Service Letter: 426 (page 1 of 2)

Title: Inspection / Upgrade of Wing Tip Navigational Light Wires

Models: All Bellanca/American Champion model 7's and 8's built before August 1996 that have strobe and navigation wires running to the wing tip.

Figure 1, View of Wire and Standoff on Compression Tube

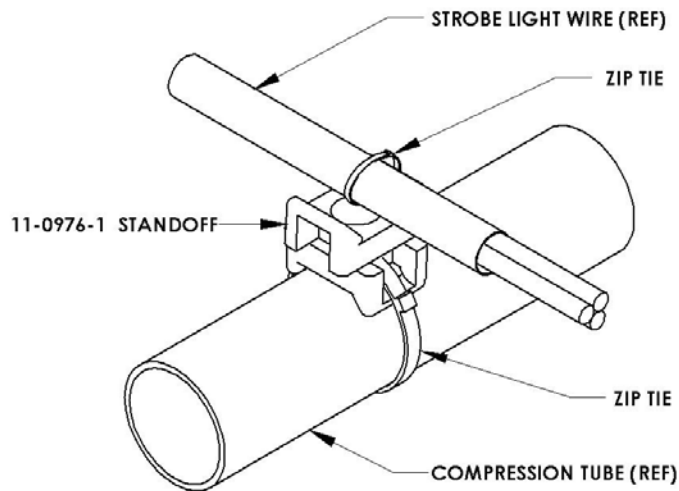
Description: Previous to August 1996, all aircraft with wing tip lights routed the wires down the center of drag truss of the wing. The wires were attached to the compression tubes with adhesive fabric tape. With time, this tape becomes brittle and can fail, allowing the wire to wear against the compression tube. There have been numerous reports of the wire chaffing through its insulation and grounding, blowing the fuse or popping the breaker.

If the wires are not securely attached, the tape should carefully be removed from the tube and wire. Upon removing the tape, inspect the wires for any signs of chaffing through the insulation. If chaffing has occurred replace the wire.

To preclude wire chaffing, wire standoffs should be installed to separate the strobe and navigation wires from the compression tubes. Install ACA P/N 11-0976-1, or equivalent, wire standoff directly on top of each compression member where the wire crosses using one zip tie (P/N: PLT 2S-MD or equivalent) around the compression member as seen in Figure 1. The standoff should be rotated 90 degrees to allow it to seat on the compression tube and allow the wires to be zip tied to the standoff. Zip tie (P/N: VUVT 06M M or equivalent) the wires to one side of the standoff (see Figure 1) tight enough to prevent slip between the wires and zip tie. Leave some wire slack between each standoff.
